TACKLE BOX

RESTAURANT RENOVATION AND DECK ADDITION

Planning Review Board
Revision

Pages now labeled Approved or Revised
with short description. Narritive Attached

Drawing:
**Demolition Elevation
Sides
Item #20.5**

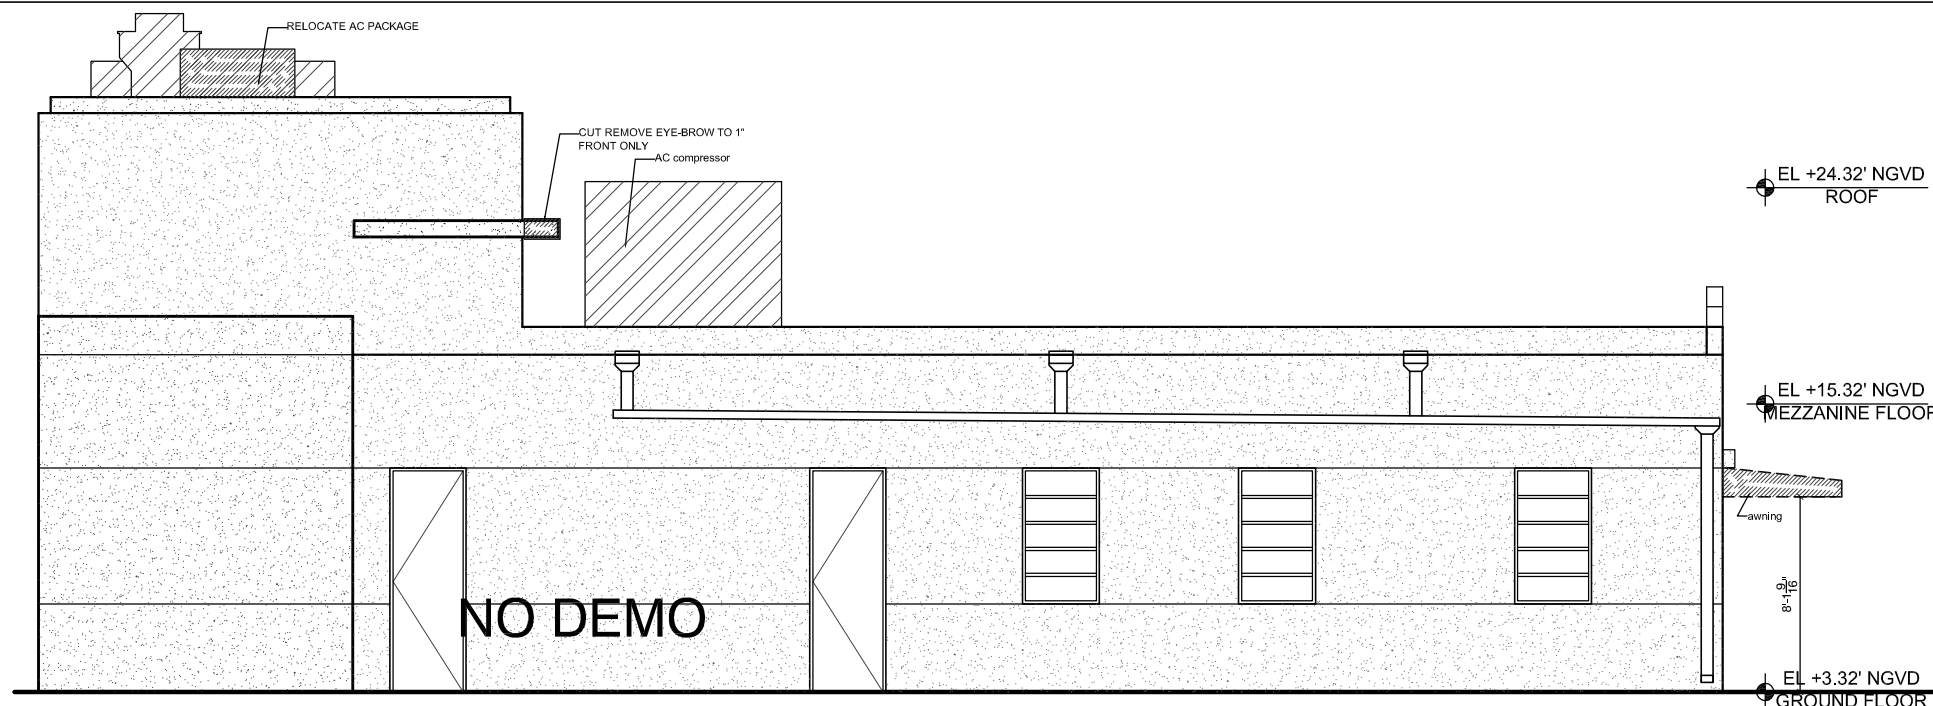
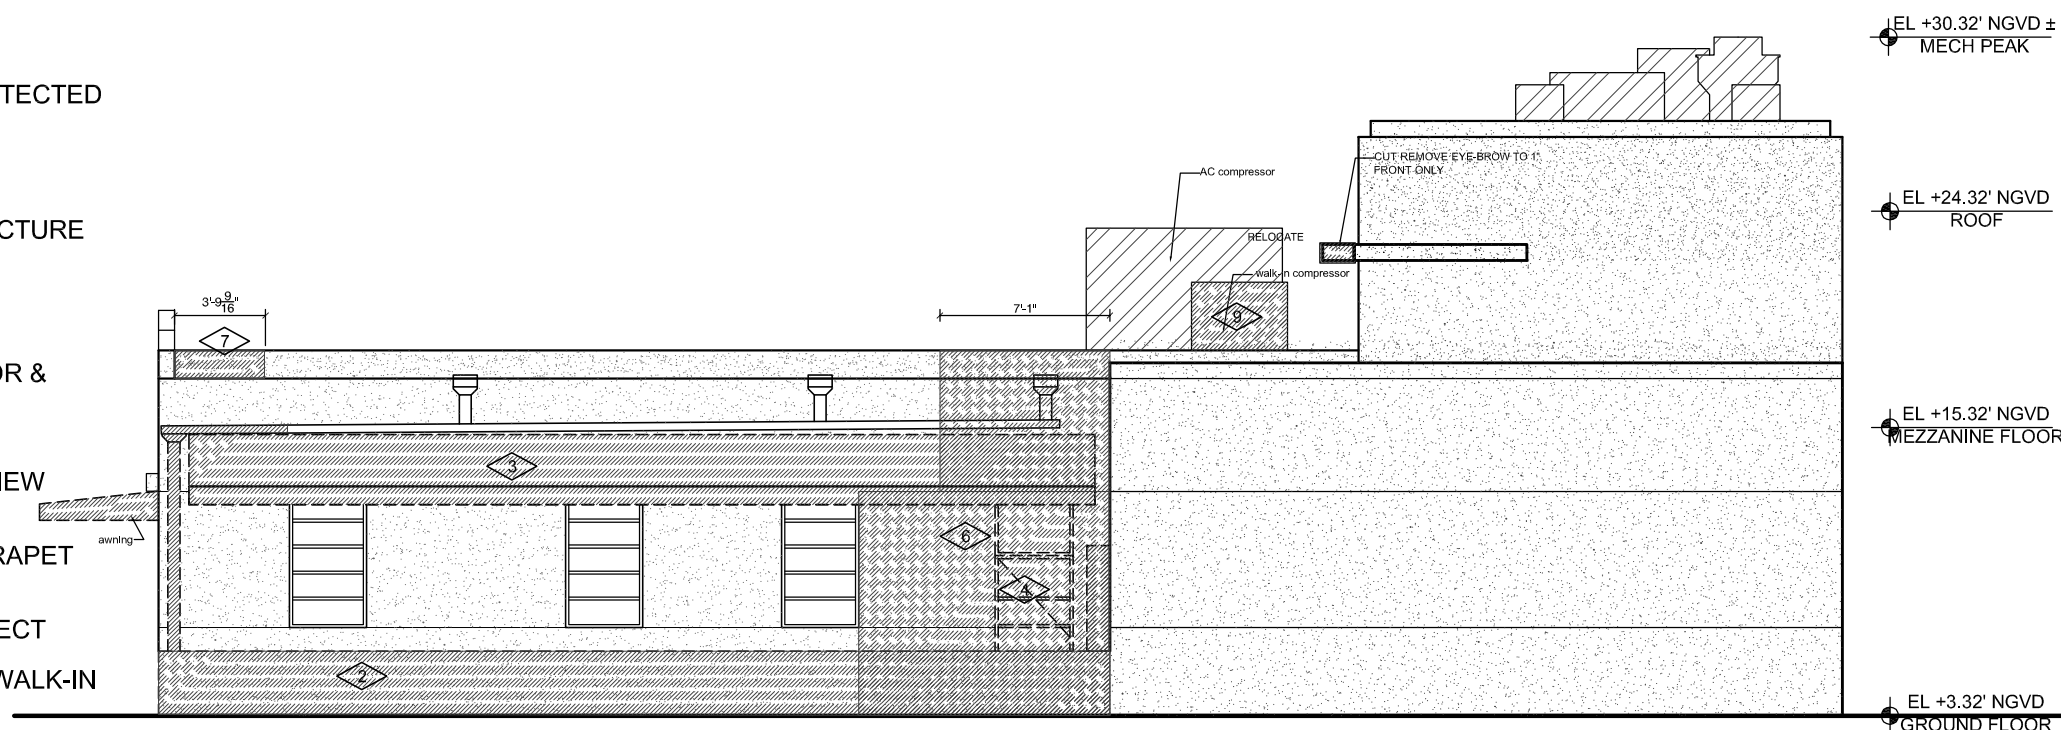
PROPOSED CHANGES/ SITE CHANGES
-STAIRCASE RISES WEST TO EAST

Proposed Floor Plans
First Floor
Item #21.1

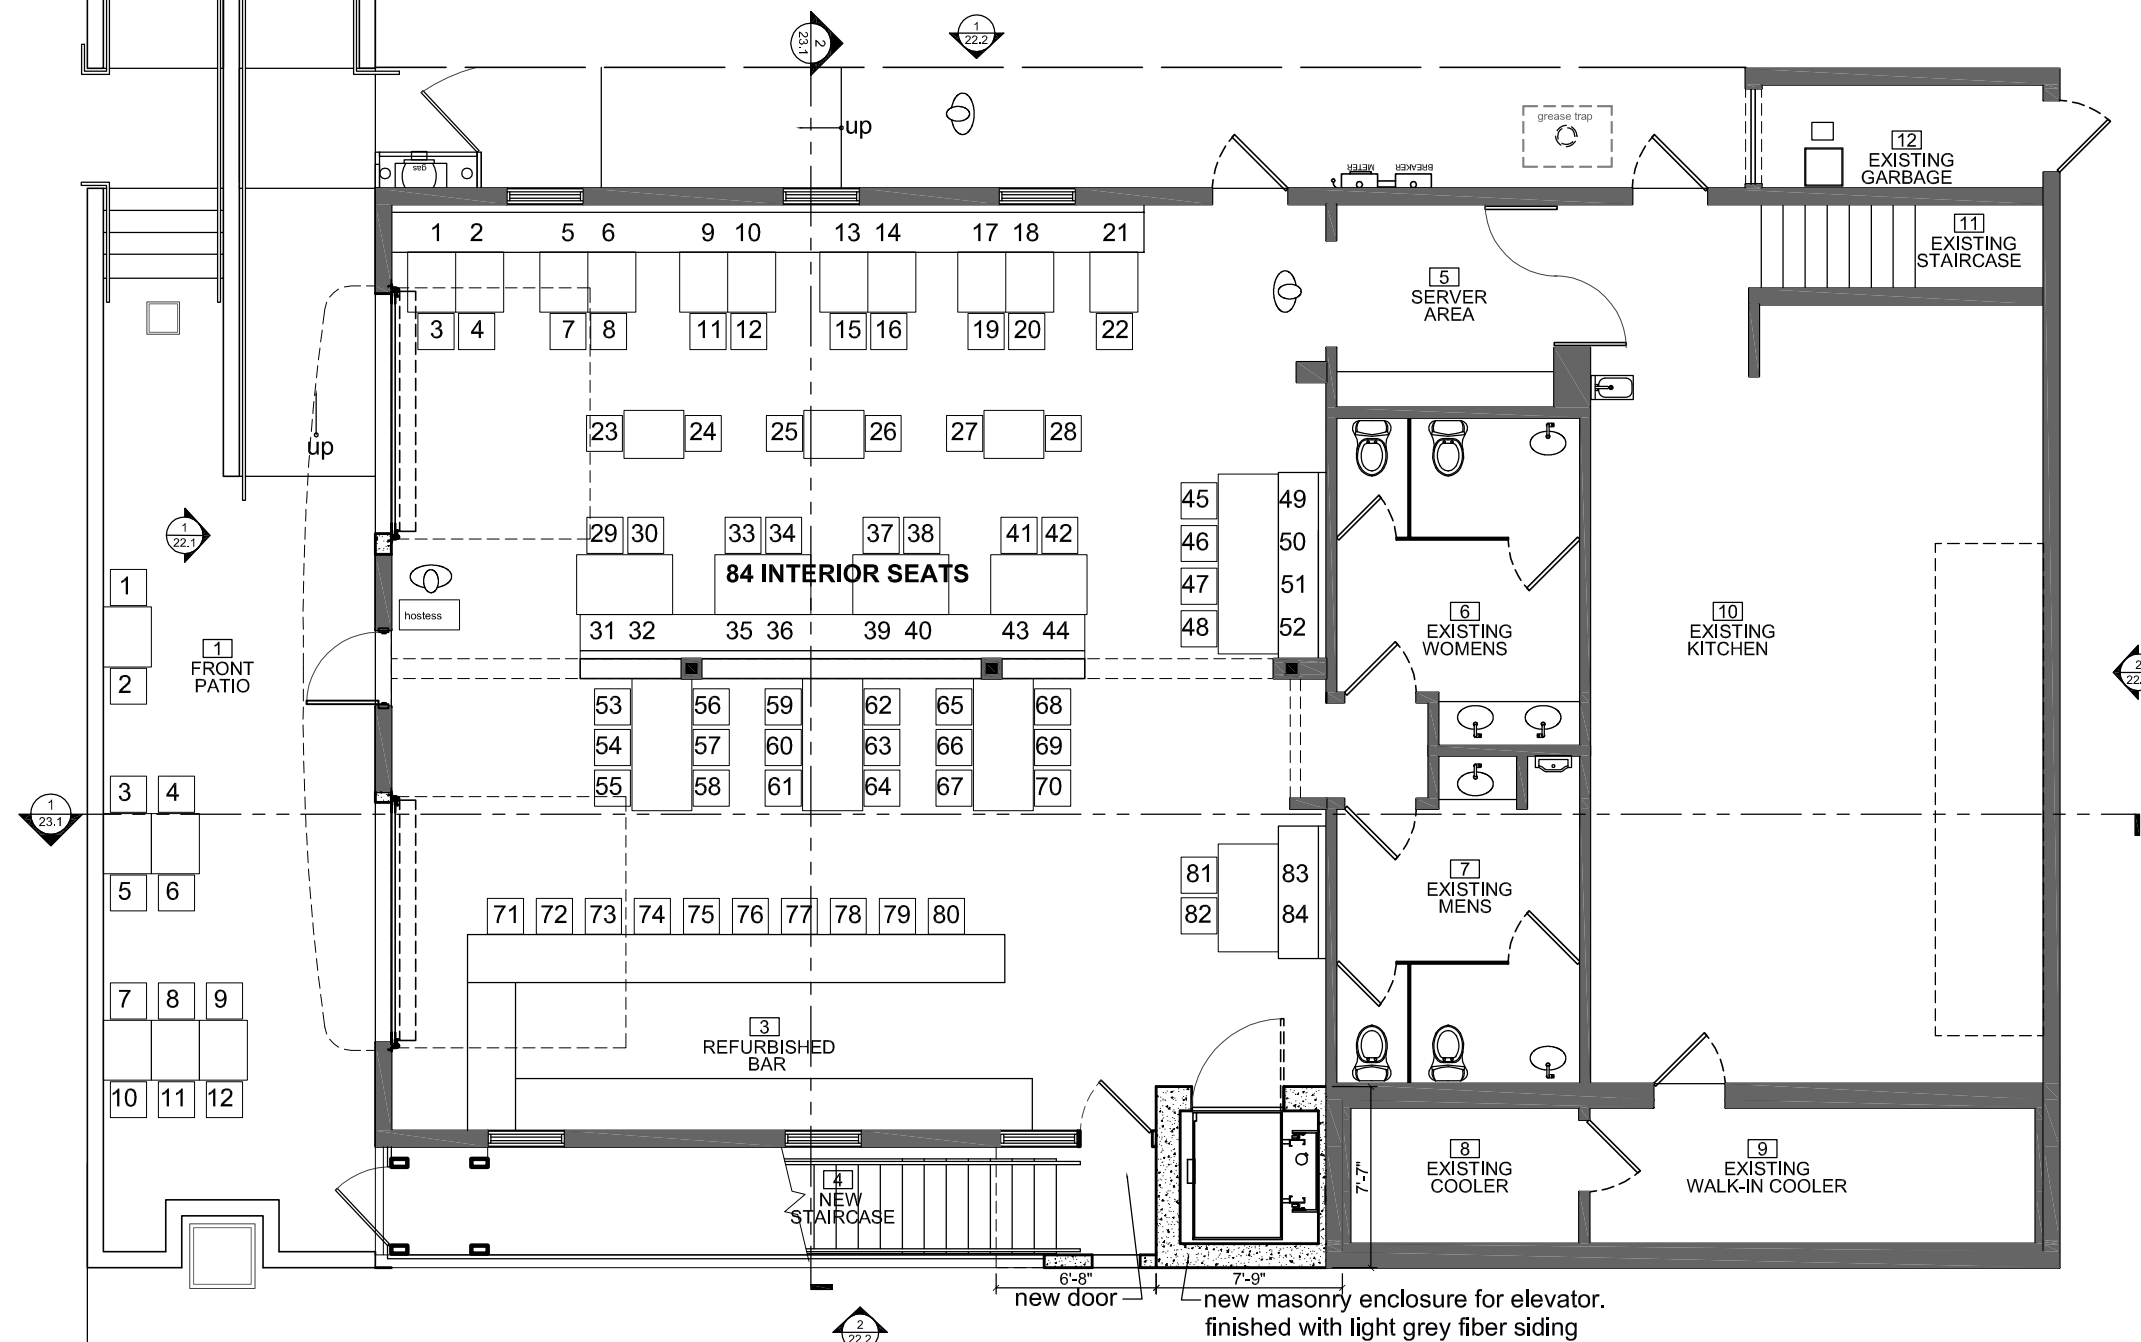
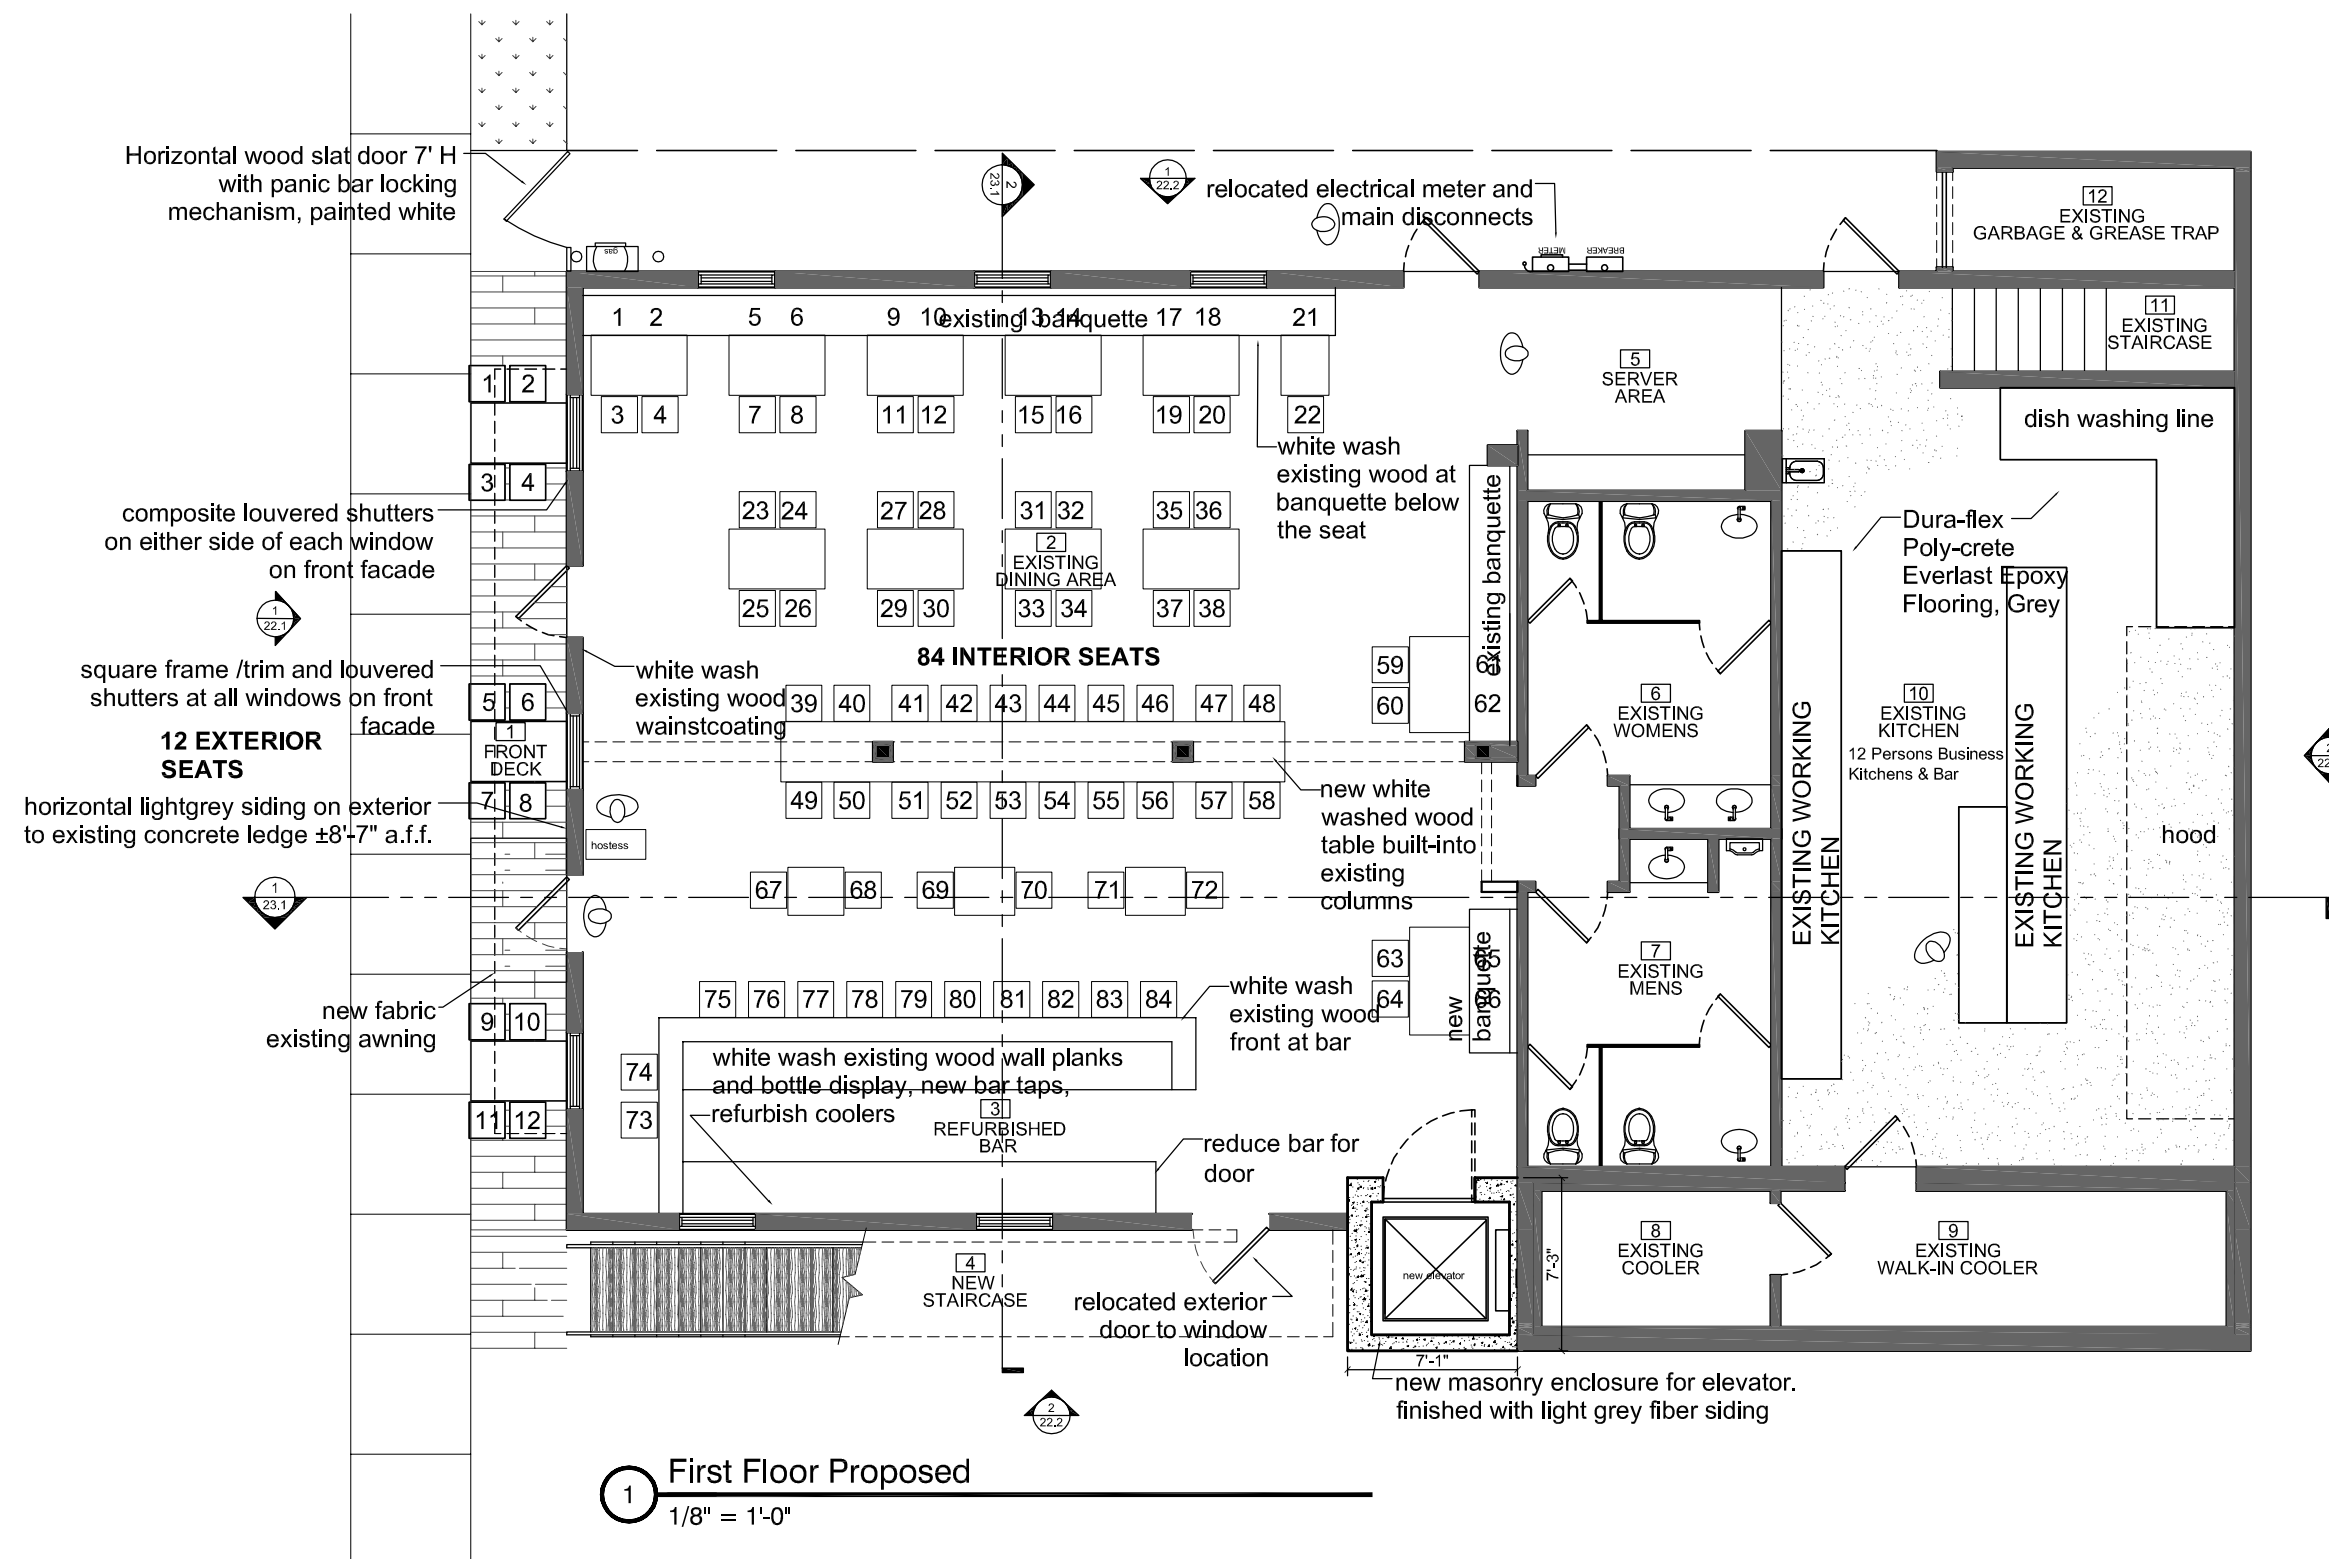
PROPOSED CHANGES/ SITE CHANGES
-ROLL UP STOREFRONT REVISED
-CITY SIDEWALK RENOVATED
